## COUNCIL ASSESSMENT REPORT

### SYDNEY EASTERN CITY PLANNING PANEL

<b>PANEL REFERENCE &amp; DA NUMBER</b>	PPSSEC-327 – DA2024/0064
<b>PROPOSAL</b>	Application under State Environmental Planning Policy (Housing) 2021 for three additional storeys to Building A (street facing) and an additional storey to both Building B and C with 41 units (24 units allocated to affordable housing) and amendments to internal basement layout to provide 50 additional car spaces. The additional units under this application will sit atop the building approved under DA2020/0143
<b>ADDRESS</b>	Lot 100 DP 1282477 [25 George Street, North Strathfield]
<b>APPLICANT</b>	UPG HALSTON PTY LTD (Sid Mawad)
<b>OWNER</b>	The Trustee for SGE HIGH ST UNIT TRUST
<b>DA LODGEMENT DATE</b>	10 April 2024
<b>APPLICATION TYPE</b>	Development Application (Alterations or additions to an existing building or structure)
<b>REGIONALLY SIGNIFICANT CRITERIA</b>	Section 2.19(1) and Clause 3 of Schedule 6 of <i>State Environmental Planning Policy (Planning Systems) 2021</i> declares the proposal regionally significant development as: Council related development over \$5 million

**Figure 9:** Extract of Height Plane Diagram showing extent of building height non-compliance at Building A **Source:** Applicant's drawing no. DA503 (Revision I), prepared by Fuse Architects, dated 12/07/2024)

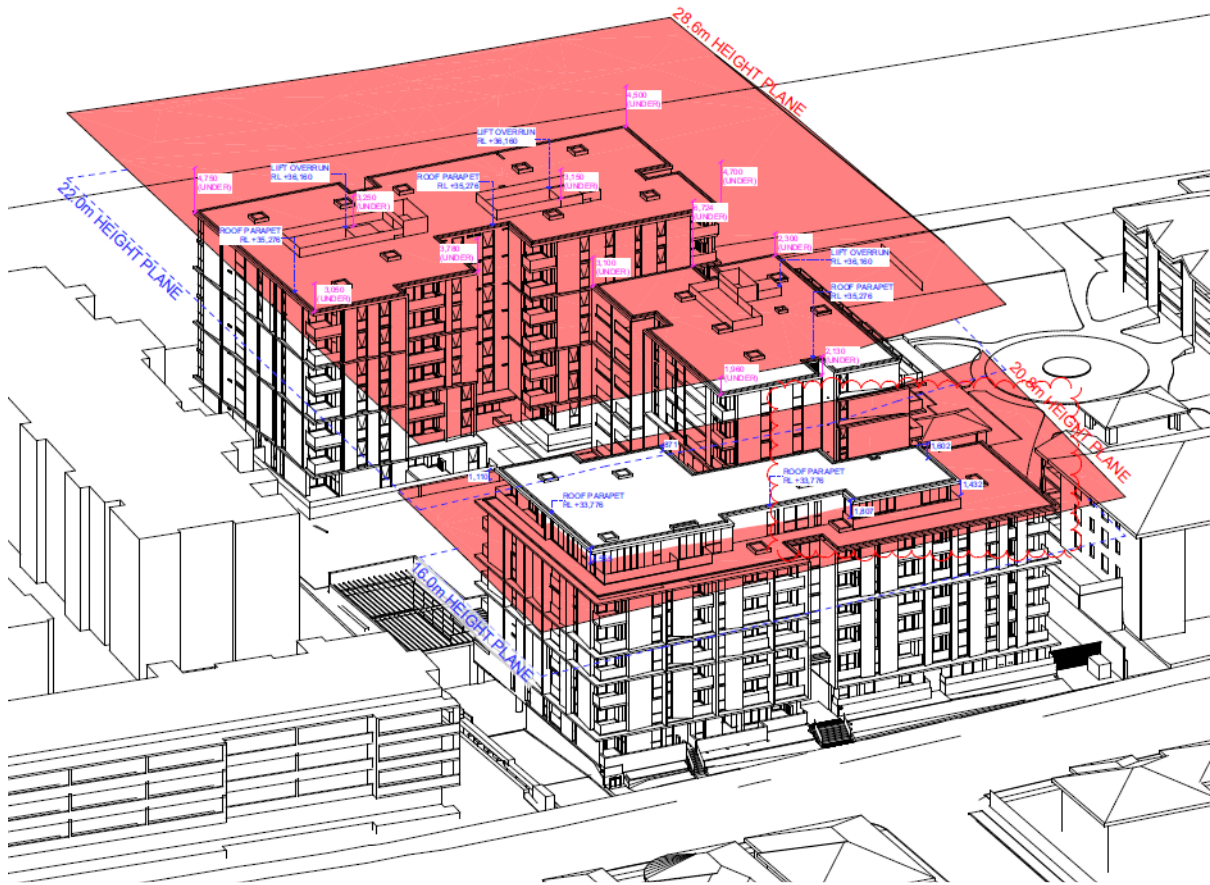
The applicant seeks to vary LEP Clause 4.3(2) Height of buildings and Clause 18 of the Housing SEPP. The variation being 1.807m or 8.6%. Refer to visual representation of non-compliance in the figure below.

The proposed development has a maximum height of **23.12m**, therefore exceeding the development standard by 1.807m or **8.6%**.

In consideration of the applicant's written submission, Council is satisfied that it is unreasonable and unnecessary to require strict compliance with the Height of Buildings development standard under Clause 4.3(2) of the CBLEP 2013, and that there are sufficient environmental planning grounds to justify contravening the Height of Buildings standard for the reasons set out below.
